MEMORANDUM

Subject: Bank of America Appeal/Findings and Conclusions

A RESOLUTION OF THE CITY COUNCIL OF THE CITY OF KIRKLAND ADOPTING FINDINGS AND CONCLUSIONS AND REVERSING THE DECISION OF THE DESIGN REVIEW BOARD GRANTING DESIGN REVIEW APPROVAL TO THE BANK OF AMERICA/MERRILL GARDENS MIXED USE PROJECT AT 101 KIRKLAND AVENUE. (FILE NO.: DRC 07-0006; APPEAL CASE NO.: APL08-0001)

Re: Comments and Suggested Revision regarding Proposed
Findings and Conclusions
Appeal Case No. APL08-00001; DRC 07-00006

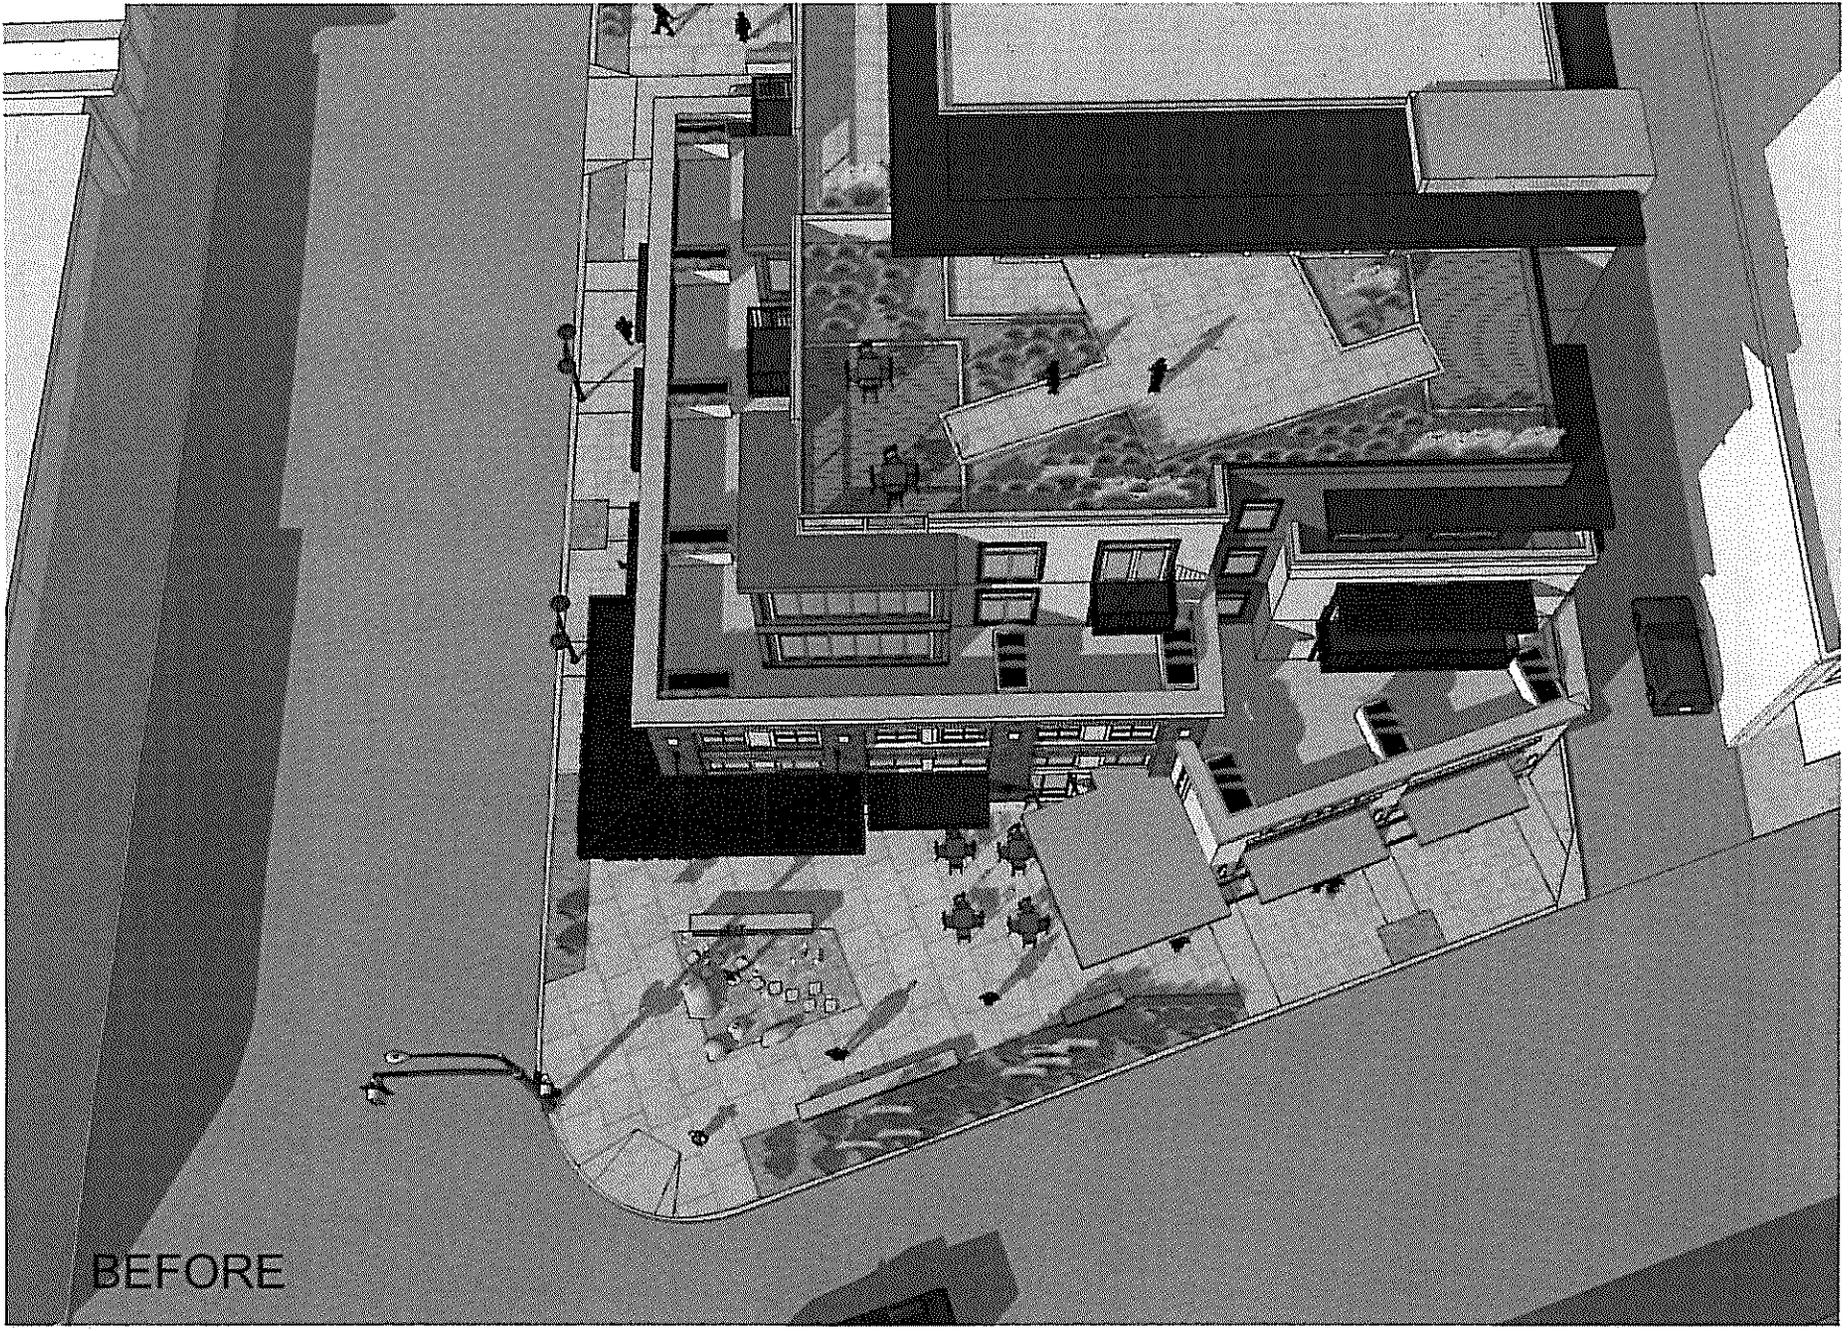
As part of its comments on the Findings and Conclusions, SRM has proposed modifying the Council's decision from a reversal of the DRB's approval of the BOA/Merrill Gardens project to an approval of the project as modified. As the Council acknowledged during its May 20th meeting, you have authority to consider modifications under the Kirkland Code. KZC 142.40(11)(b)(3). To facilitate this discussion, SRM has included revised renderings of the project showing increased setbacks between the second and third stories and between the fourth and fifth stories along Lake Street South. We believe that this revised design should resolve any

outstanding questions or concerns regarding the building's compliance with the Lake Street height restrictions. We offer this design as an alternative for your review and approval as a modified design.

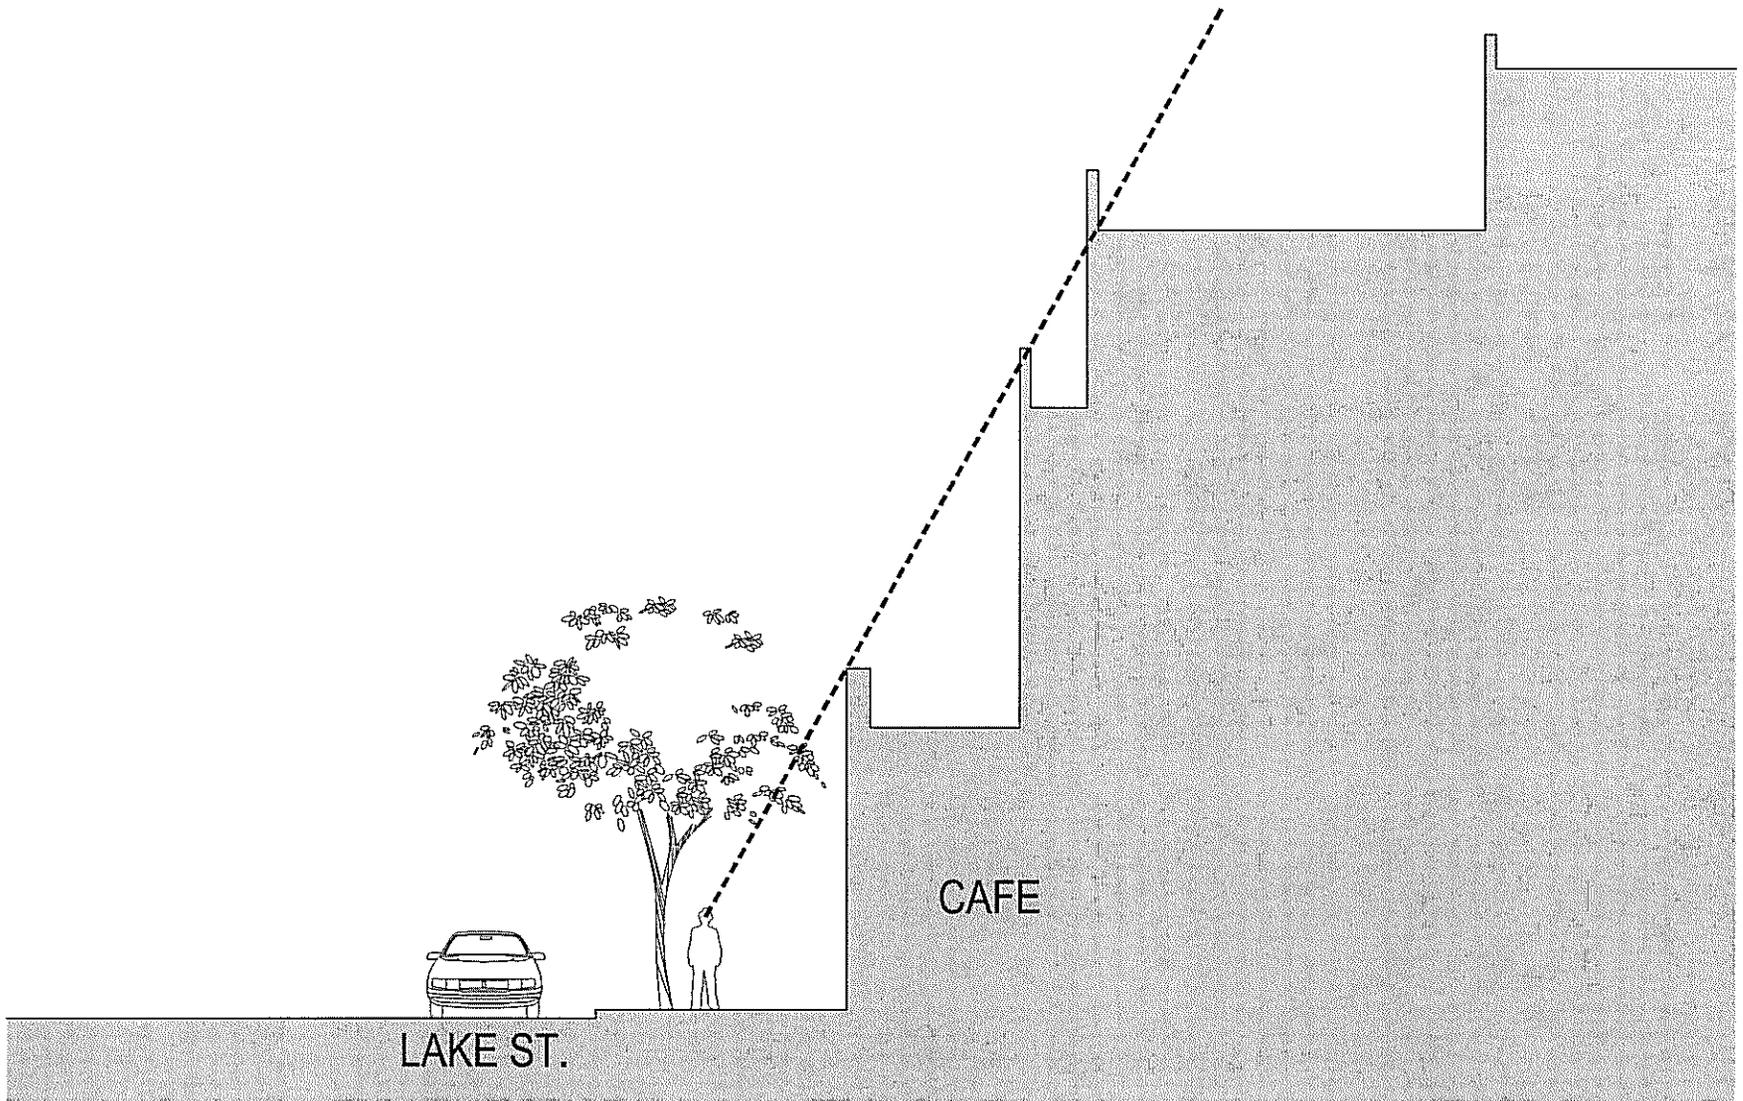
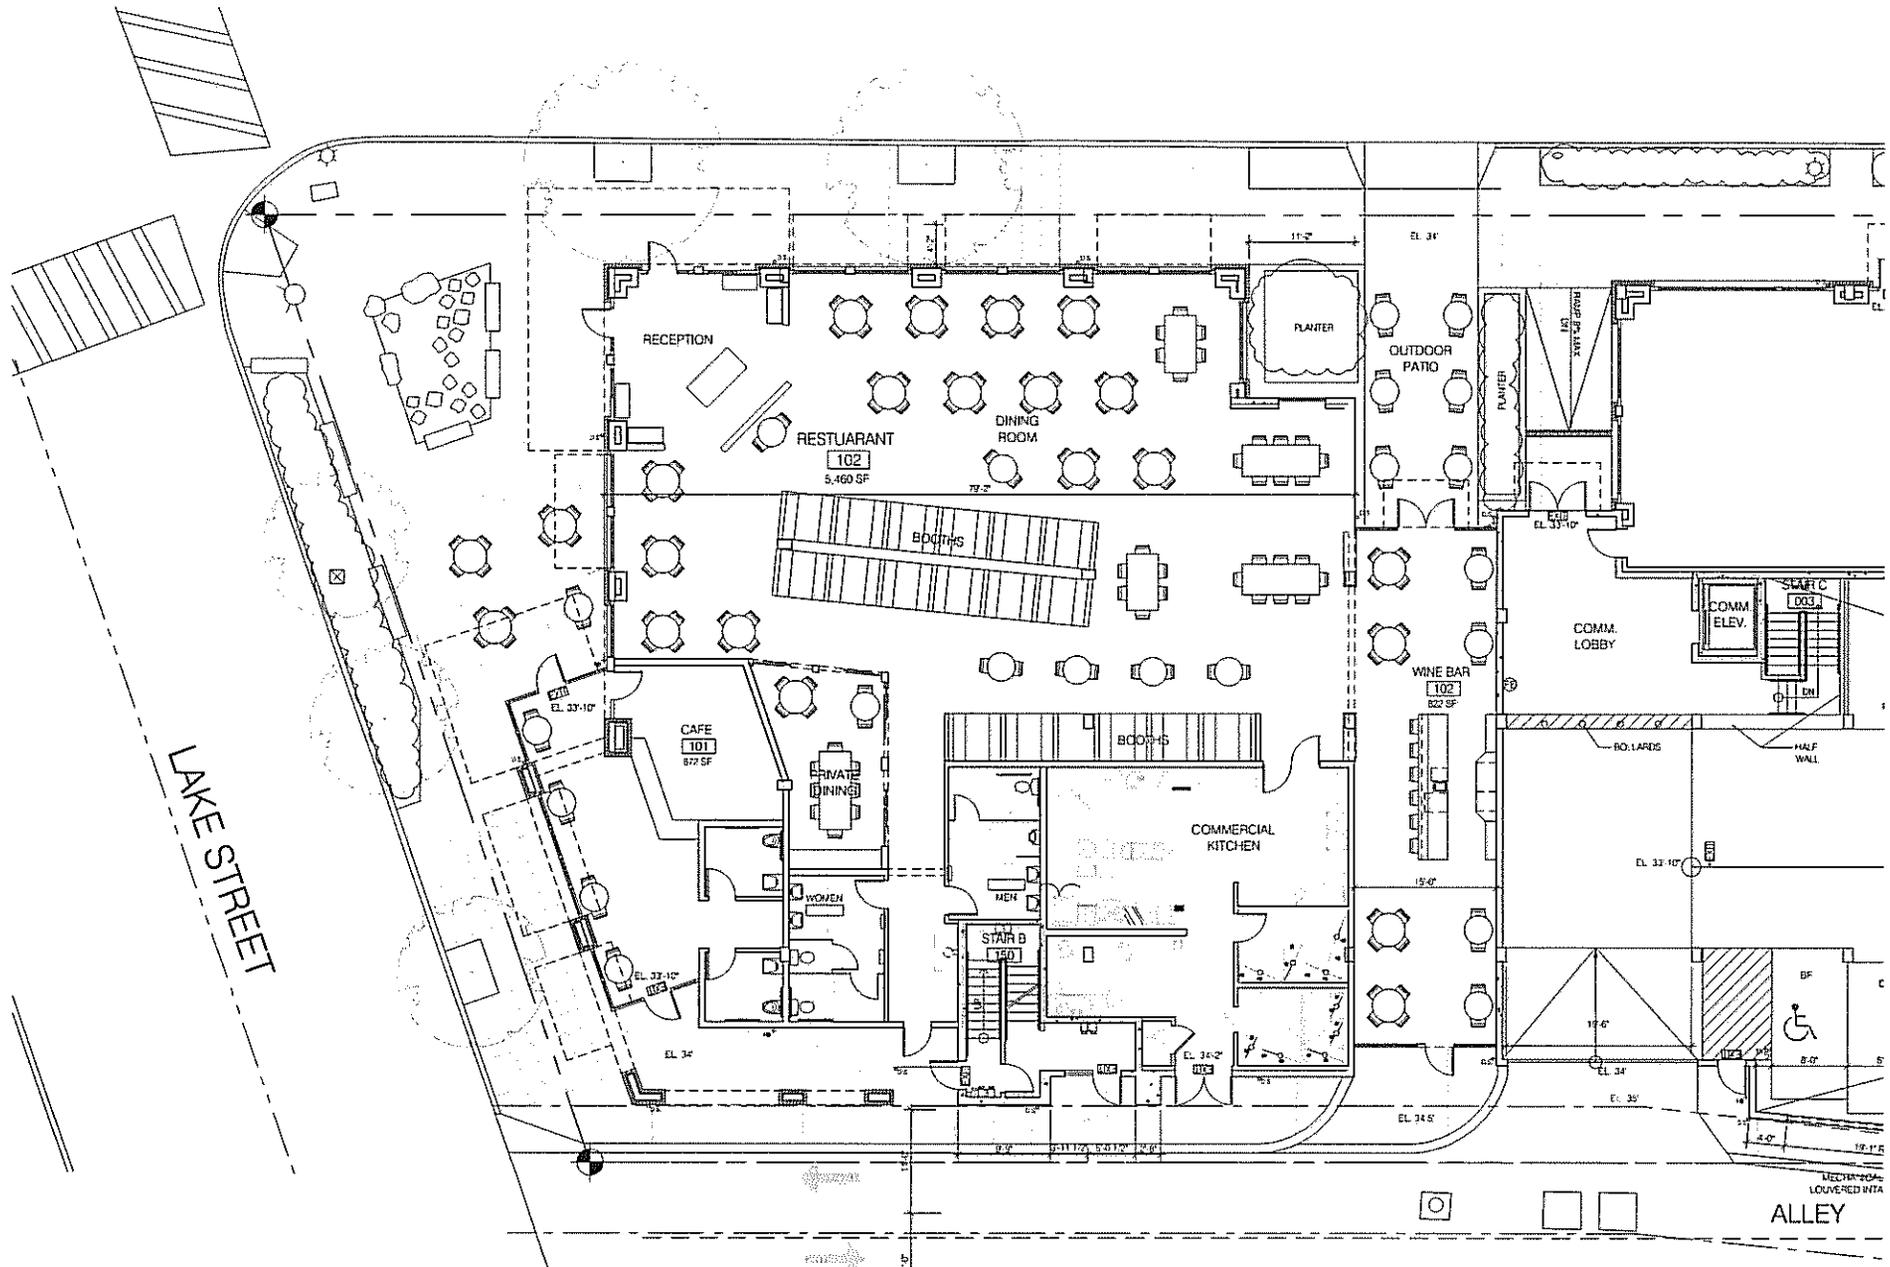
in the deliberations expressly concluded that the project met the Lake Street height restrictions, reversed his vote on this issue without explanation. Consequently, while SRM agrees with staff's interpretation that the entire project need not be limited to 2 stories, SRM remains unsure of what degree of stepback above the second story is necessary to satisfy the Lake Street height restrictions. SRM requests clear direction from the Council regarding exactly what is required to meet the Lake Street height restrictions. In an effort to advance the dialogue regarding this issue, SRM has enclosed proposed modified renderings of the project showing additional stepbacks at the third and fifth stories. If acceptable, SRM requests that the Council approve this design as modified.

The Bank of America project as approved by the DRB is not consistent with the Council's interpretation of the height limitation on Lake Street South, as articulated in paragraph 5.3 above, because the third and fourth floors are not setback from the second floor, nor from Lake Street South, far enough. [*Delete the remainder of the paragraph and insert guidance regarding how large the stepback must be to meet the Council's interpretation of the Lake Street height restriction.*]
